PLANNING COMMISSION MEETING

Project Name: Culver's
 Description: Final site plan approval and PDA approval recommendation
 Date on Agenda this packet pertains to: October 3, 2024

RE: Culver's- Final Site Plan/Final Engineering Plan Review – 2nd Review

**Revised Final Site Plan Review
for
White Lake Charter Township, Michigan**

MSTS Unit: MH1
 Water Quality Rate (III-18)

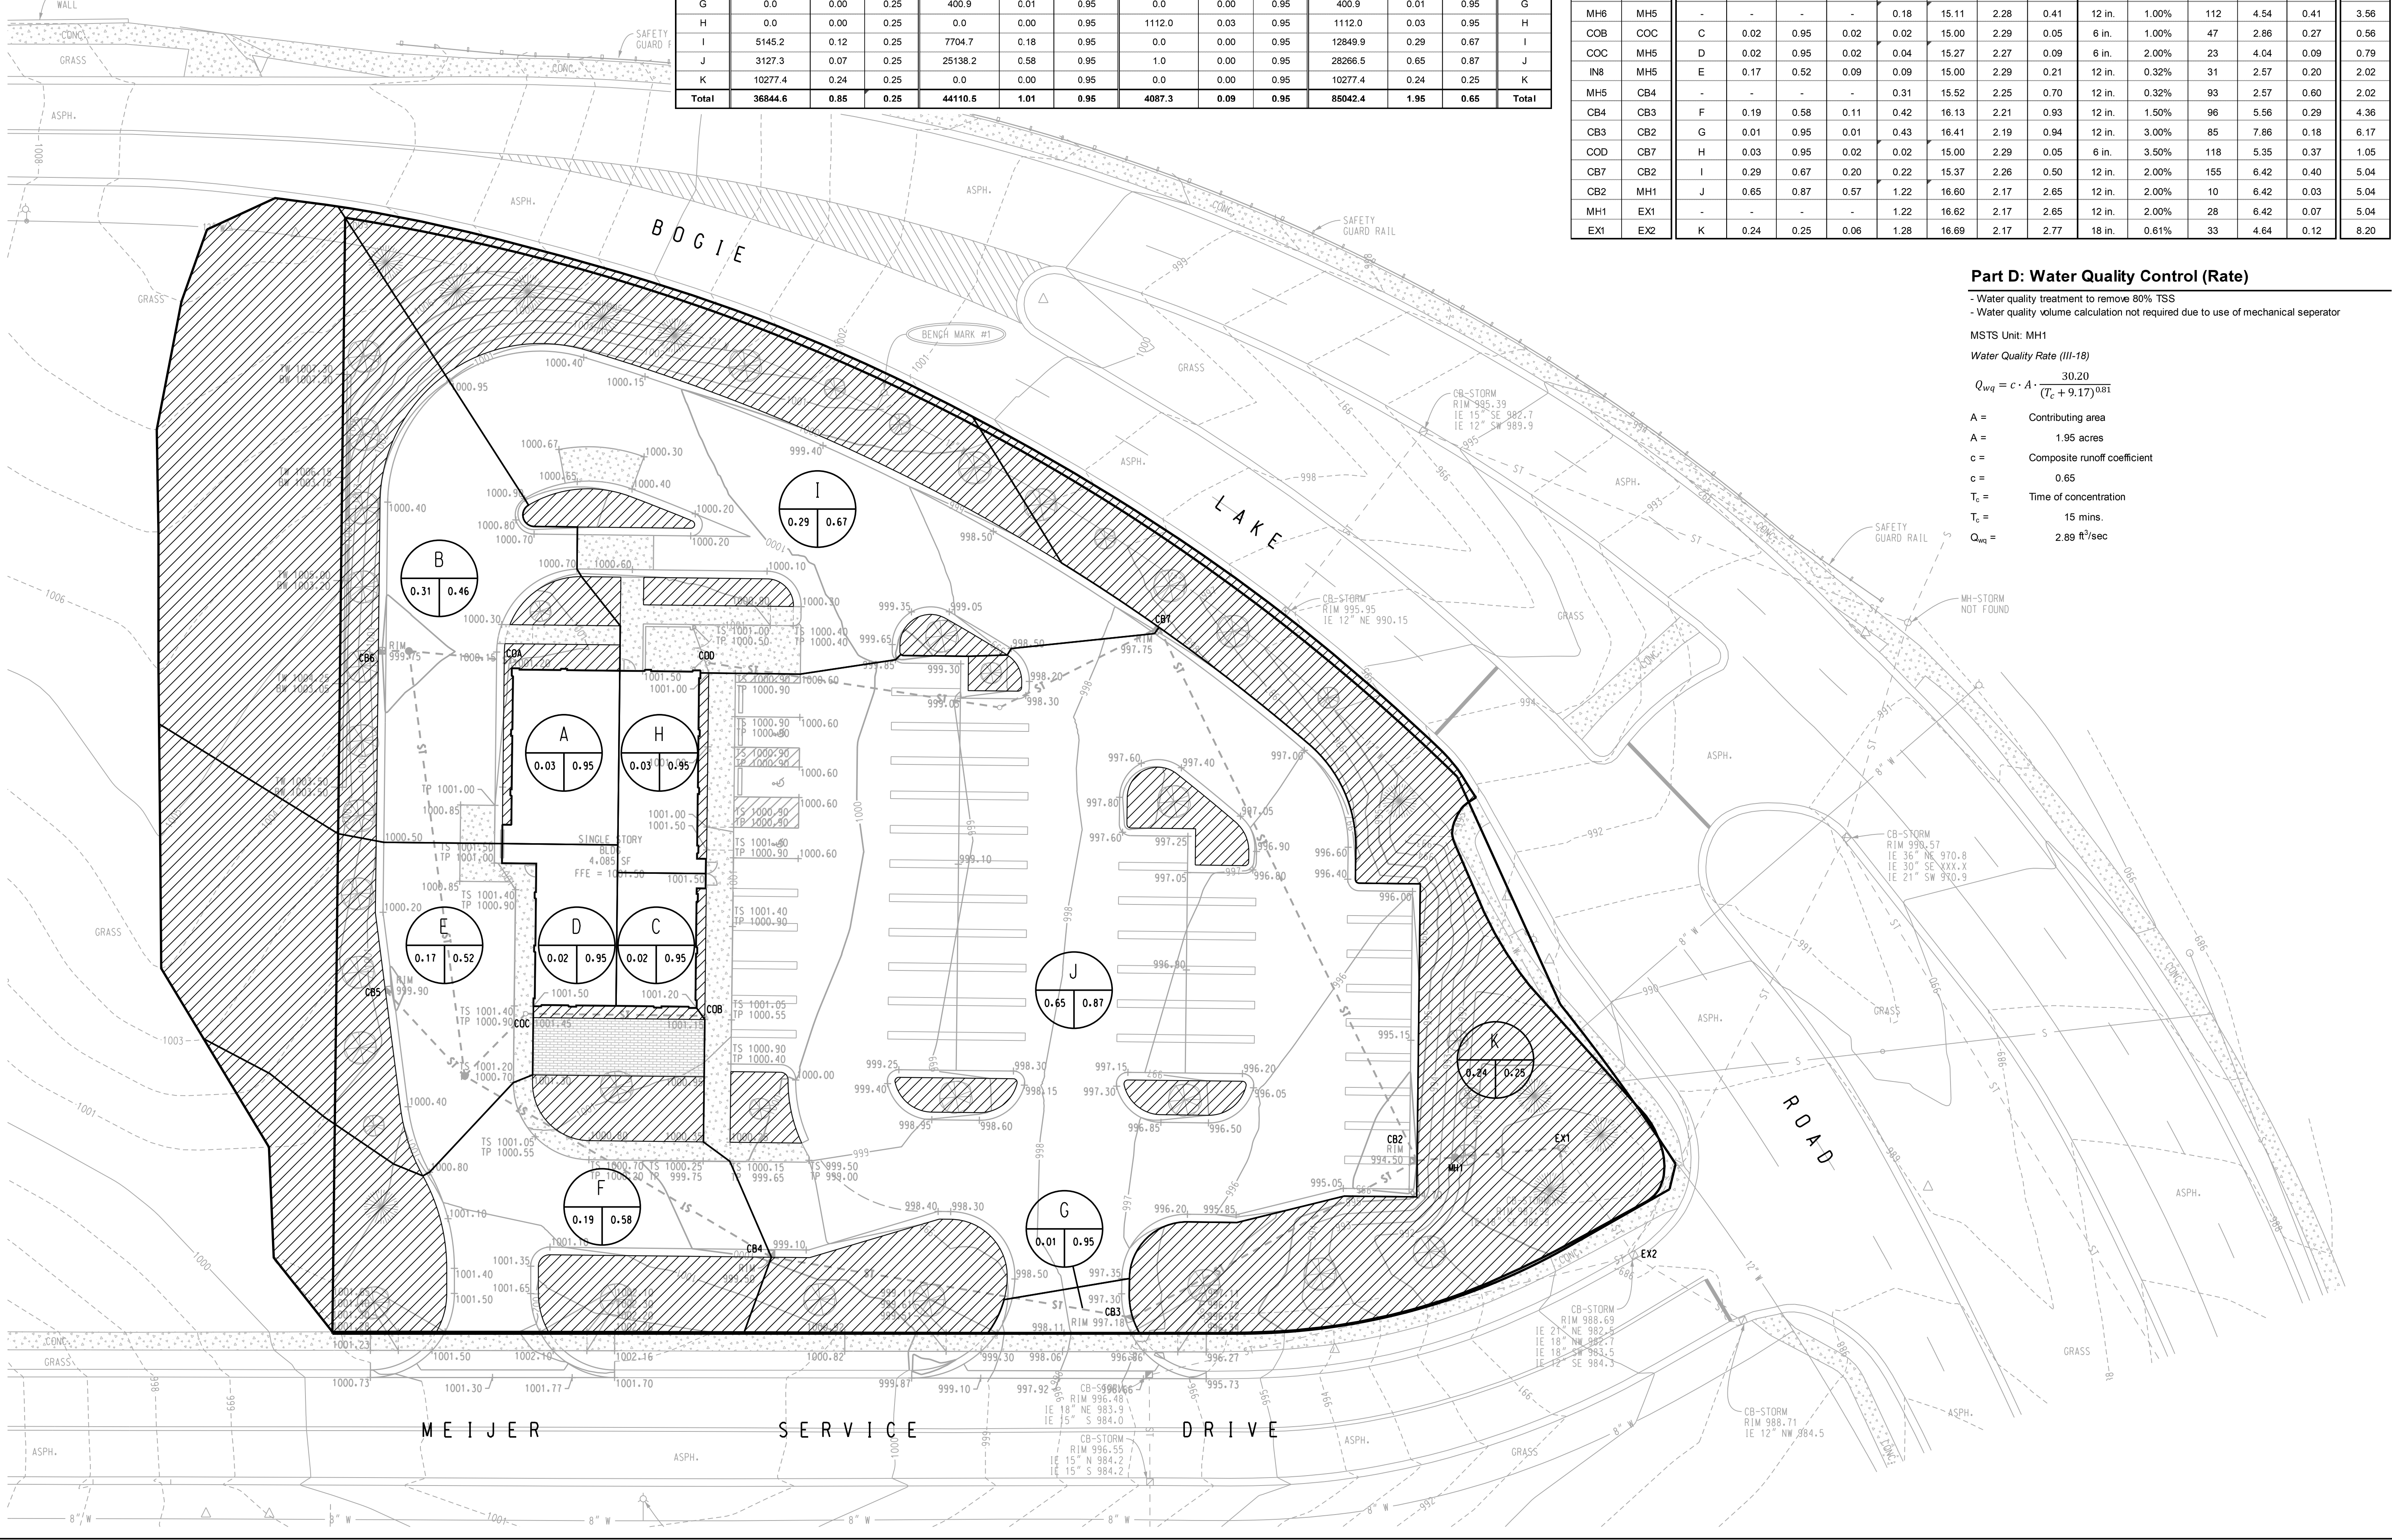
6. *Sheet C303- Part D: Water Quality Control (Rate)- Time of concentration shall be 15 minutes for commercial developments; currently 20 minutes is shown. **Comment addressed. Time of concentration has been revised to 15 minutes.***
